Power Up Your Car

M3-ATX Serial cable with certain mainboards

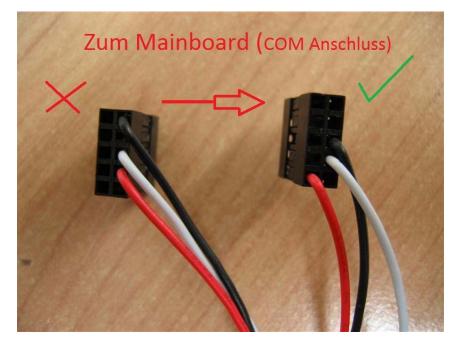
With some mainboard's serial header pinout you get a Timeout error while trying to program M3-ATX. To fix it, you need to modify the serial cable harness :
